# Response to Submissions to the Public Exhibition

Spring Farm Resource Recovery  
Facility S.75W Modification  
Application (05\_0098 MOD 5)

Prepared for  
SITA (Australia) Pty Ltd

12 January 2015

**Figure 1: Predicted 99th percentile ground level odour concentration due to combined emissions from Spring Farm ARRT/MRF, Landfill, Camden Soil Mix and Tripodi (upset conditions)**

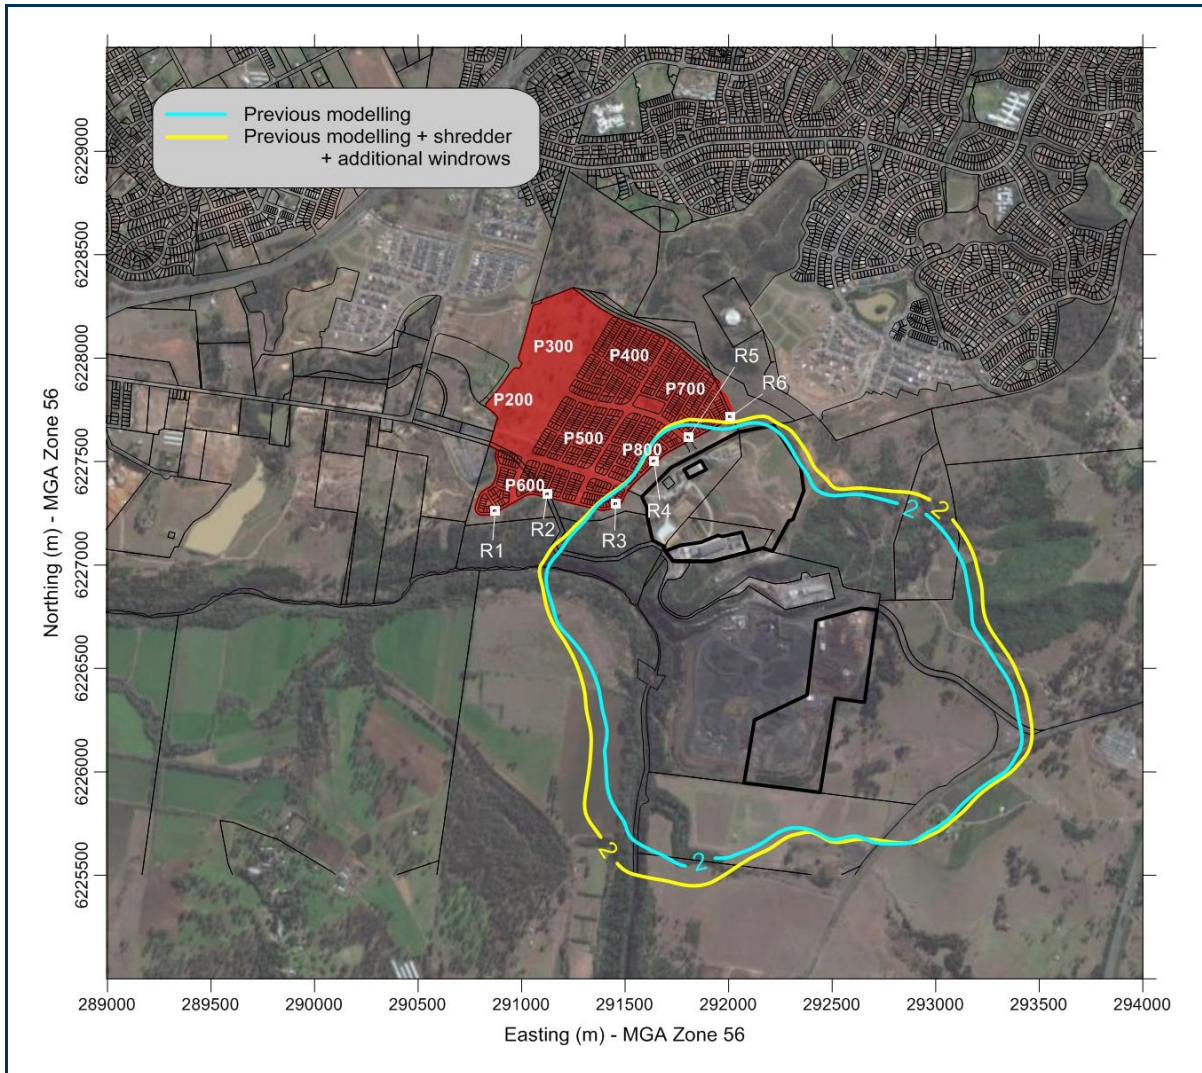
Camden Council has made a submission objecting to the proposal on the basis that there is an inconsistency between the Air Quality and Odour Impact Assessment for the ARRT facility, prepared for SITA, and a Level 3 Odour Assessment for the same area, prepared for Urban Growth. Pacific Environment’s response in the attached letter can be summarised as follows.

- That the odour contours illustrated in Figure 1 in the letter (reproduced below) represent worst case “upset conditions” and are also most representative of conditions before the Camden Soil Mix site underwent significant odour mitigation works in 2012. To assume that these conditions would occur all year is a very conservative position.
- That odour contouring is an interpolation of whole number readings. Results for specific locations are therefore better interpreted using tables of predictions made specifically at those location rather than contour plots, which will interpolate (approximate) between grid points within the modelling domain. Predictions were made at six boundary receptors (as shown in **Figure 1**). These results are presented in **Table 1** and show that there are no predicted exceedances of the EPA 2 OU criteria at these receptors located at the site boundary.

**FIGURE 2\*. Modified Biotreatment Facility - proposed process flow diagram.**

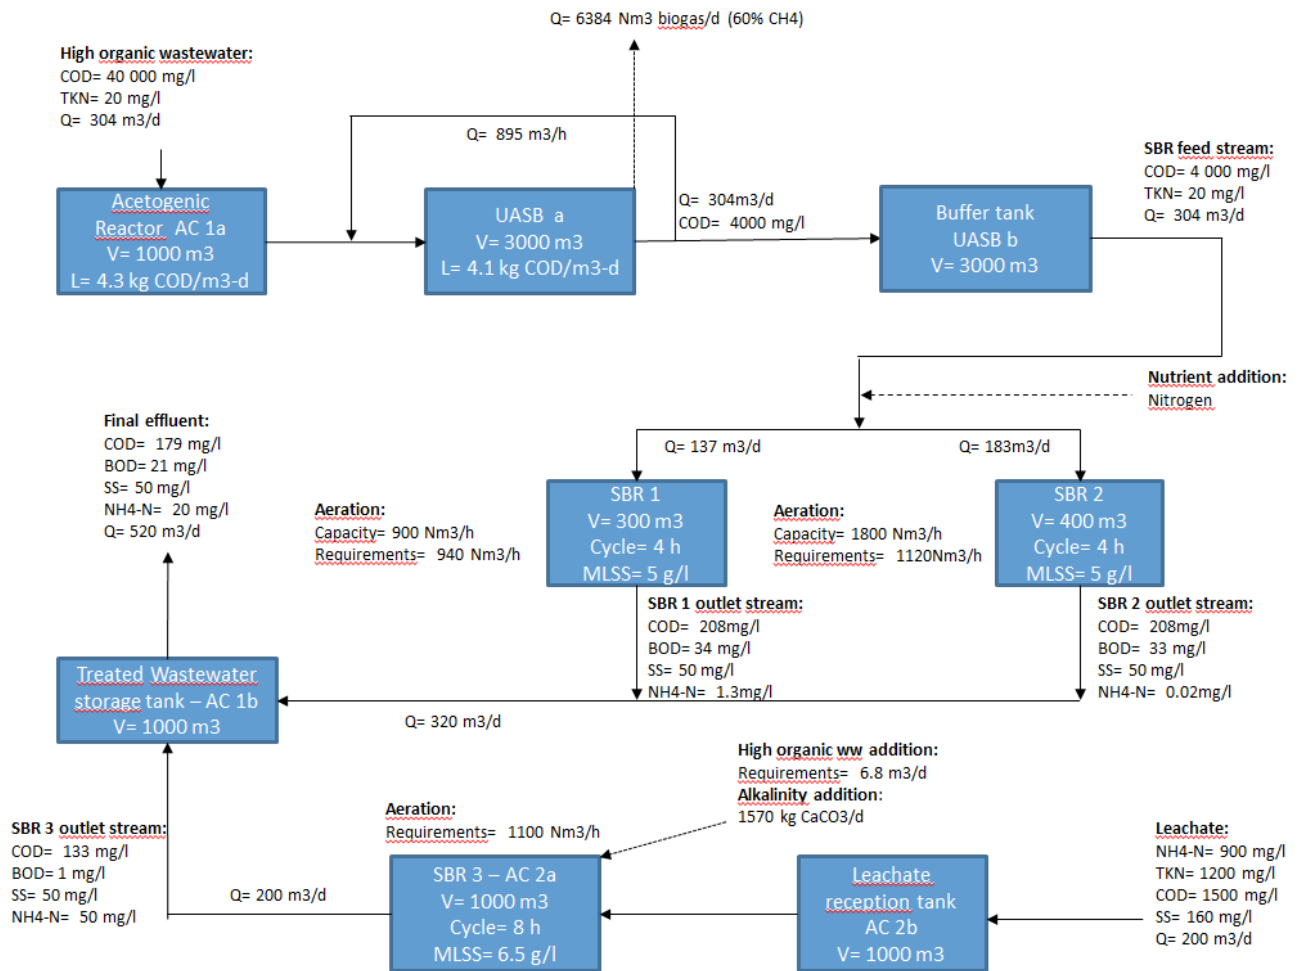
An input / output balance is included at Figure 2 in the amended Spring Farm Biotreatment Facility Fit for Purpose Report (Suez Environment, January 2014), a copy of which is attached to this submission at Appendix B.

The input / output balance figure is included in the report on the final page before to the appendix section. Please refer to “*Figure 2\*. Modified Biotreatment Facility – proposed process flow diagram*”. Figure 2 and accompanying information of the Fit for Purpose Report, Appendix D to the initial submission’s response, has been attached to this submission as **Appendix A**.

**Figure A: Predicted 99th percentile ground level odour concentration due to combined emissions from Spring Farm ARRT/MRF, Camden Soil Mix and the Jacks Gully Landfill (standard operating conditions)**

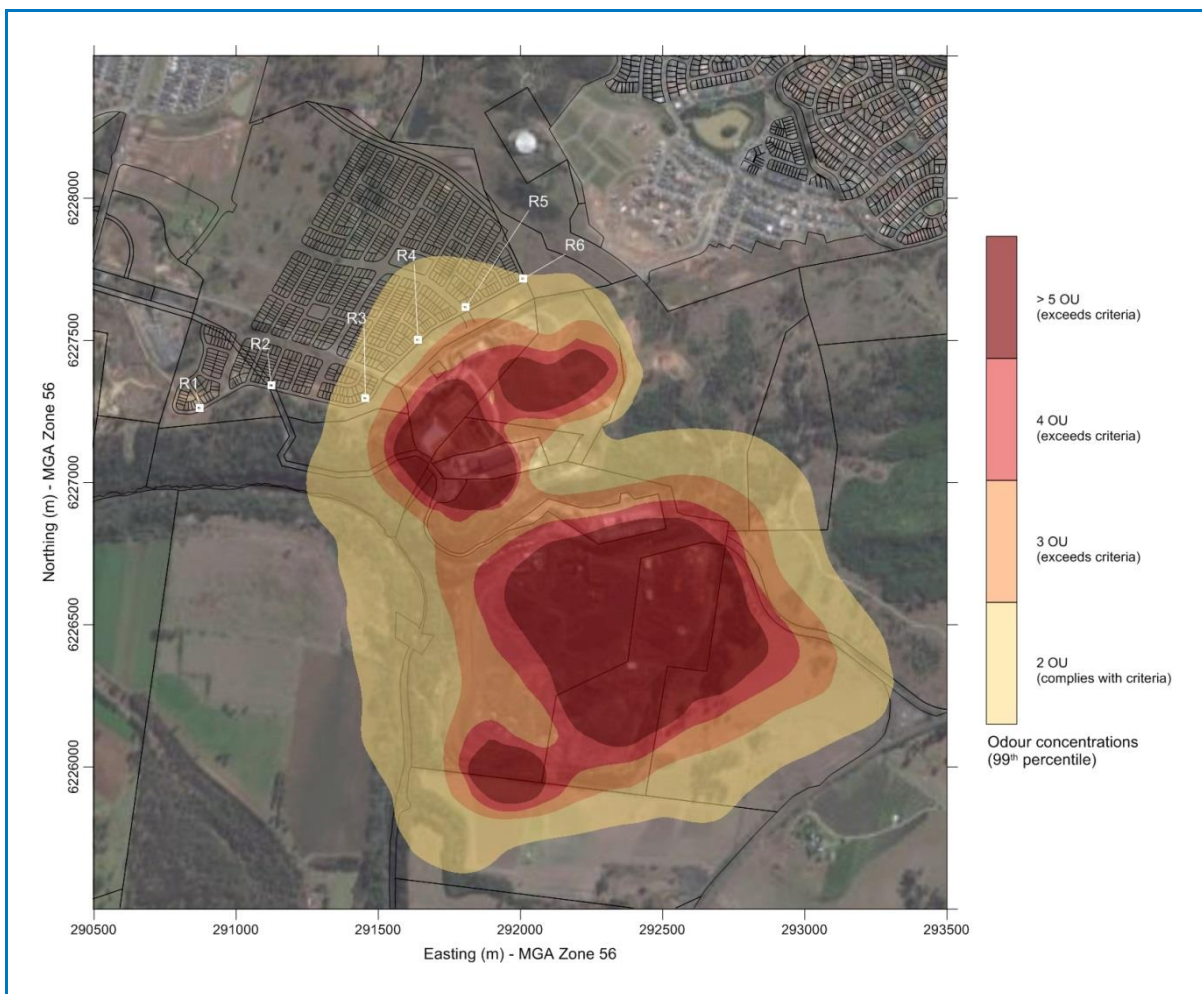
Specifically, Council states that they do not accept that the results presented in Table 1 and Table 3 of the Pacific Environment letter report reflect the results presented in the contour plots in Figure 1 and Figure 2, respectively. We acknowledge how this conclusion could be drawn by comparing the tables directly with the figures in the absence of additional contextual information around the interpretation of odour modelling results.

Figure 1 and Figure 3 in the Pacific Environment letter report present the same information, but as contours across the whole prediction grid, which have been interpolated (approximated) between prediction points. When these results are presented as contours in this way, the contouring technique references values to greater than one decimal place. For this reason, there is an apparent mis-match between values in tabular form, and those shown in our Figures.

A valid and more effective way of presenting these data in contour format is as shown in **Figure A** below, which uses the identical modelling results for those presented in Figure 3 in the Pacific Environment letter report.
